UPDATES

"Packet on the Mac"

Refer to the above article on page 8 of the October 1992 issue. The following corrections need to be made:

Figure 1. The corrected schematic diagram of the PacketMac Modem. Changes are to the TxD and RxD wiring, pin numbers on the connector and the -2.5 volt connections. Note, however that everything except the loopback test will work as originally wired.

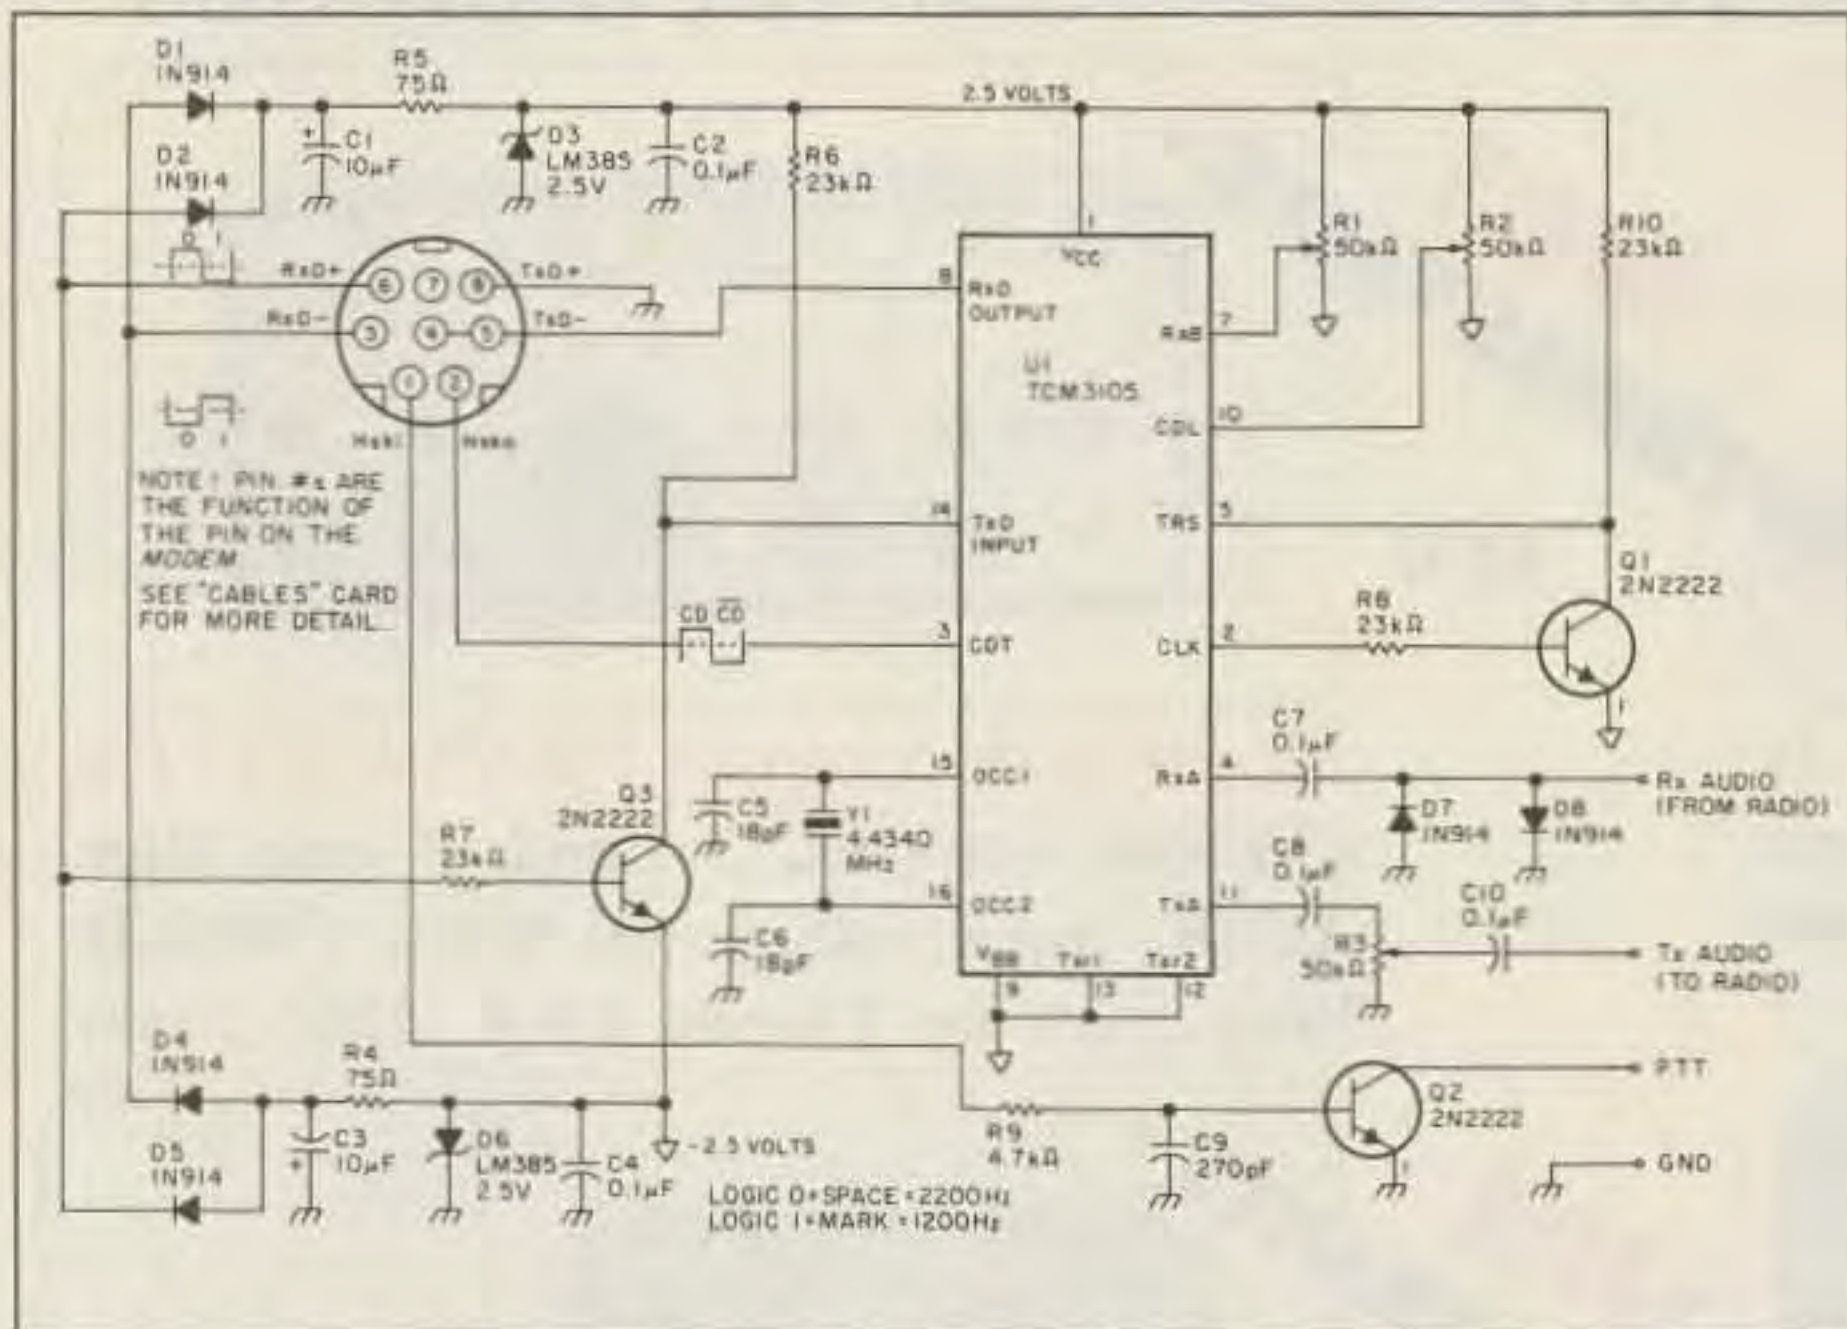
2) The bit asserted sense of the TxD+ and TxD- lines are the same as their name, not the opposite as stated in the article.

3) See Figure 1, for the corrected schematic.

Note however, that the modem will still work fine for packet as originally wired

since the NRZI encoding asserts a bit by changing state, it does not matter if the state starts high or low. The only indication that a reversal exists is that the characters received during a loopback test are the "inverts" of what was sent.

The modem can be fixed by simply

swapping the wires on the mini DIN-8 Macintosh cable where it attaches to the TxD+ and TxD- pads on the modem. You could also change the modem by swapping the wires going to the RxD+ and RxD- pads.

Figure 2. The corrected parts placement diagram of the PacketMac Modem showing the jumper wires as well as the new pad assignments (shown in red). Using these new pad assignments, just follow the wiring hookup chart in Figure 4 in the original article for the proper connections.

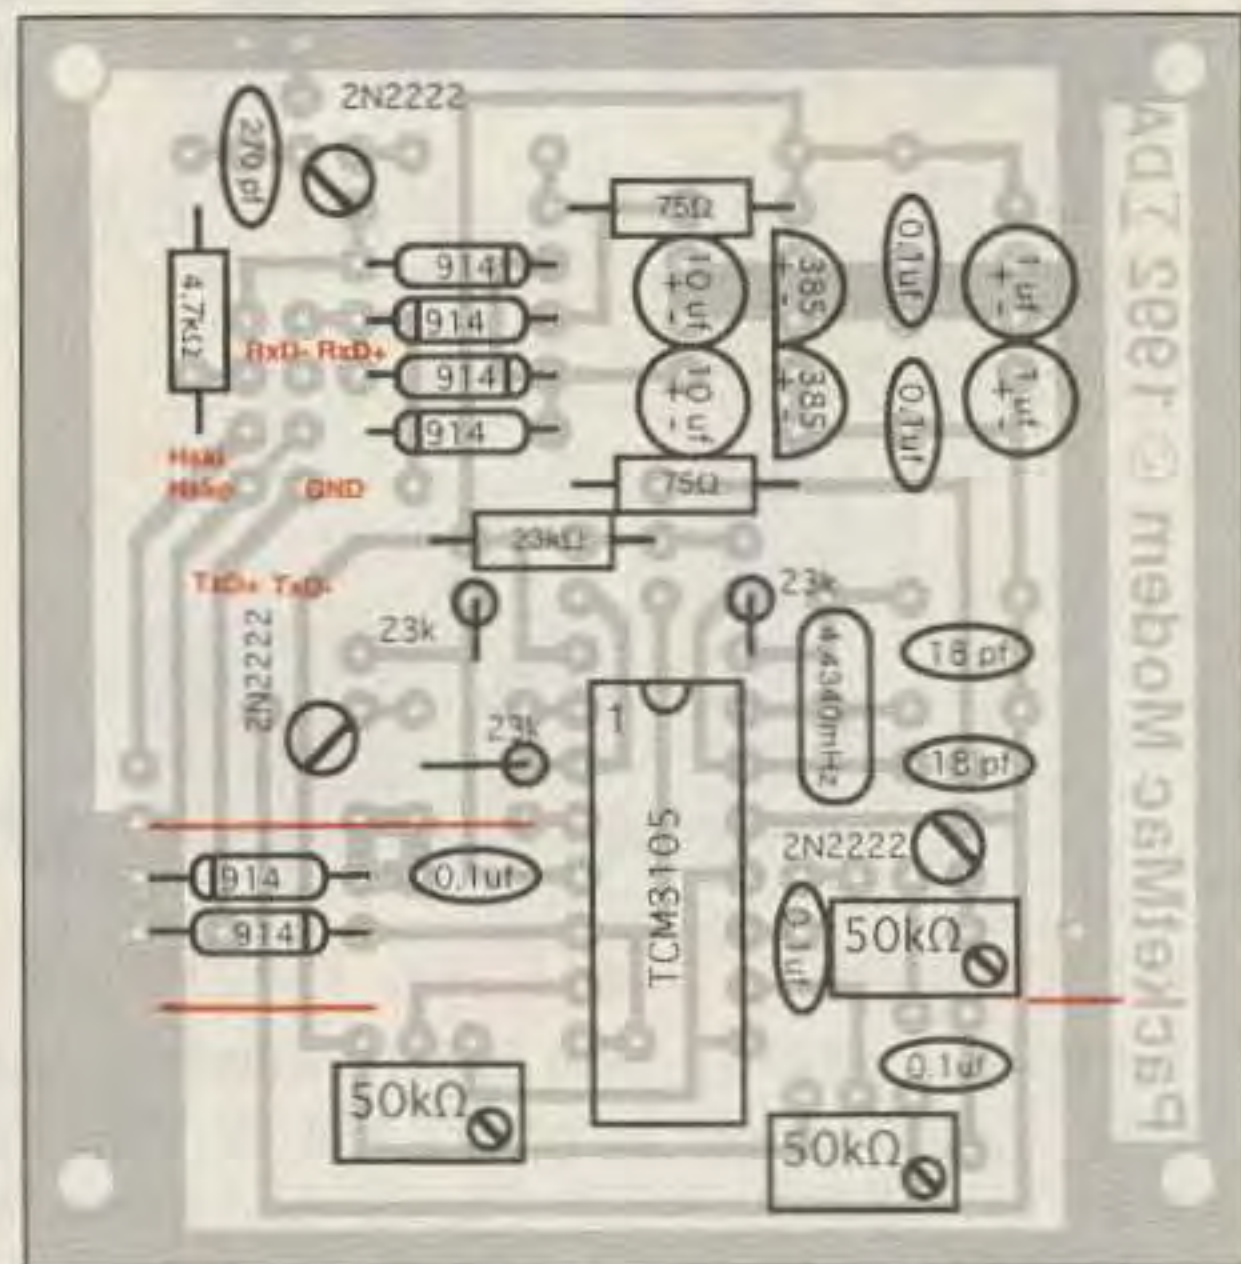
1) The jumpers were not shown on the parts placement diagram for the modem. See the corrected diagram in Figure 2.
